UNITED STATES
NUCLEAR REGULATORY COMMISSION
WASHINGTON, D. C. 20555

SUBJECT: TECHNICAL SPECIFICATION FOR RIVER BEND

Comments on Technical Specifications - River Bend

FIGURE 3.4.1.1-1

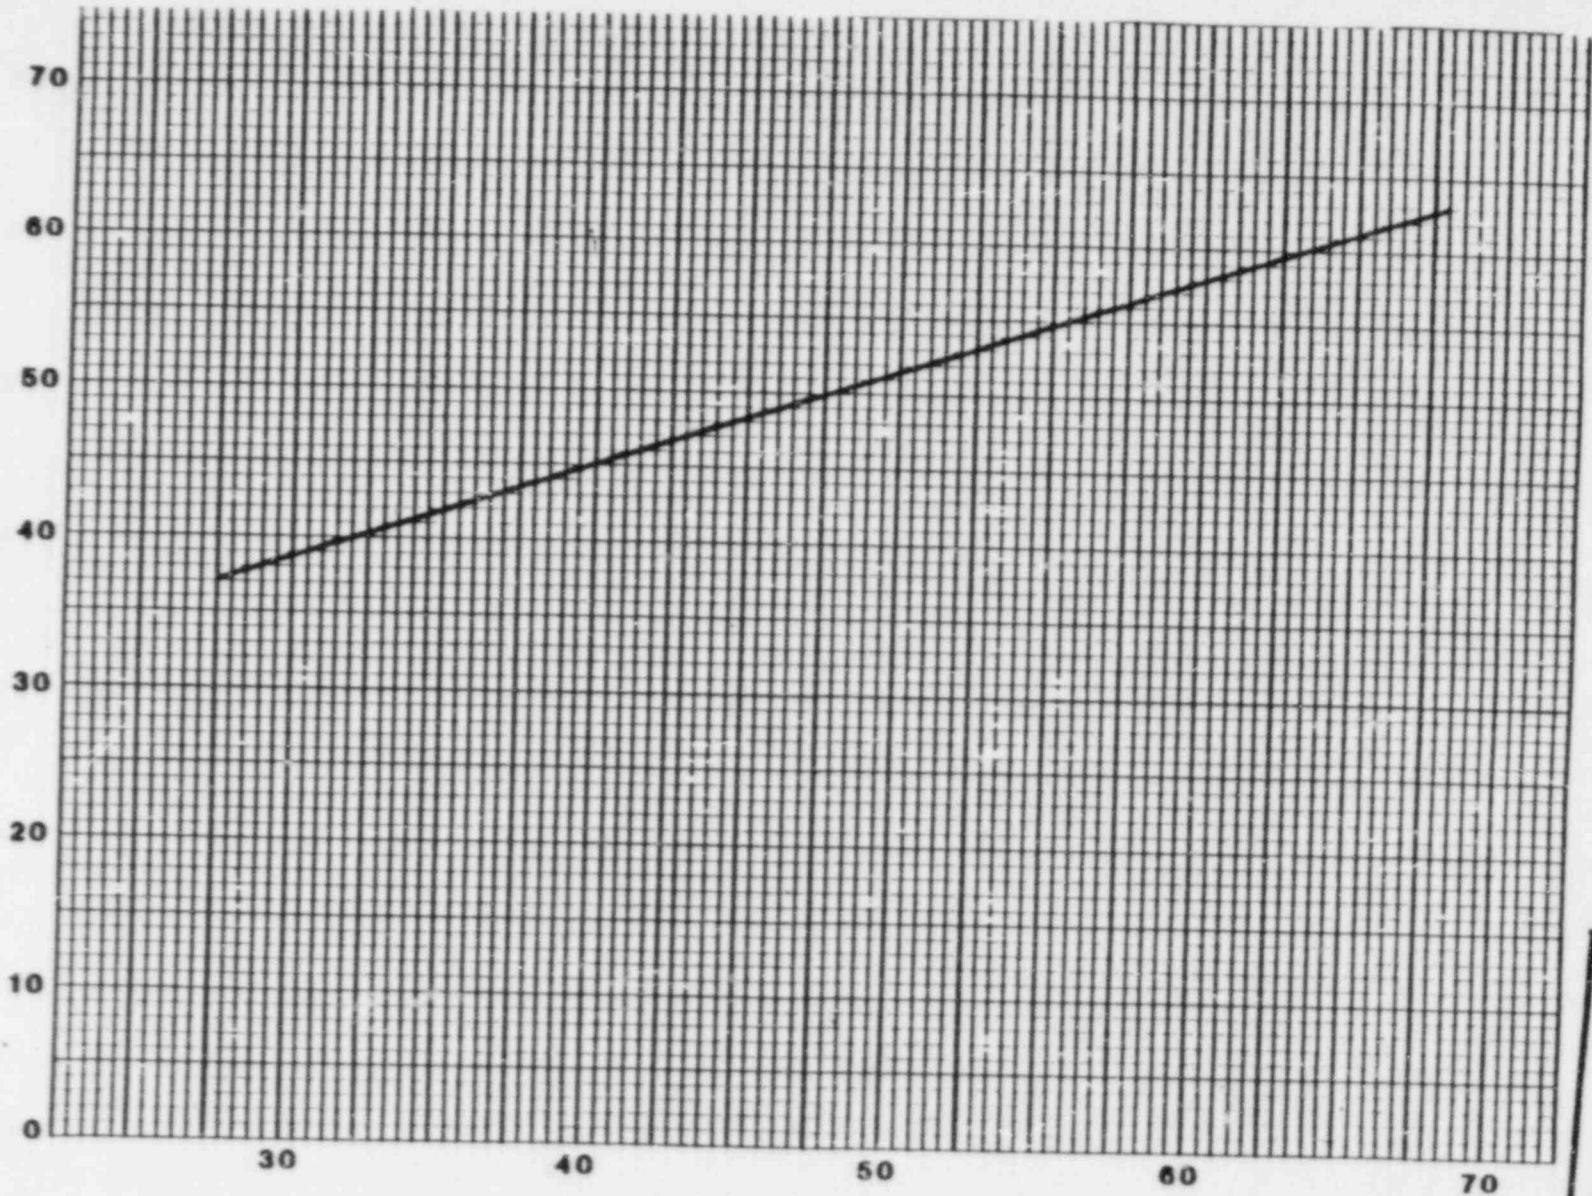
This specification as written does not address the issue of monitoring core stability in accordance with the recommendations of GE letter SIL-380. We require such monitoring and the inclusion of the requirement in the Technical Specifications. An acceptable Specification is attached. It is our understanding that the applicant is currently performing the analysis to support the inclusion of the revised Specification.

- c. With two reactor coolant system recirculation loops in operation and total core flow less than 45% of rated core flow and THERMAL POWER greater than the limit specified in Figure 3.4.1.1-1:

1. Determine the APRM and LPRM** noise levels (Surveillance 4.4.1.1.2):
 - a) At least once per 8 hours, and
 - b) Within 30 minutes after the completion of a THERMAL POWER increase of at least 5% of RATED THERMAL POWER.

2. With the APRM or LPRM** neutron flux noise levels greater than three times their established baseline noise levels, immediately initiate corrective action to restore the noise levels to within the required limits within 2 hours by increasing core flow to greater than 45% of rated core flow or by reducing THERMAL POWER to less than or equal to the limit specified in Figure 3.4.1.1-1.
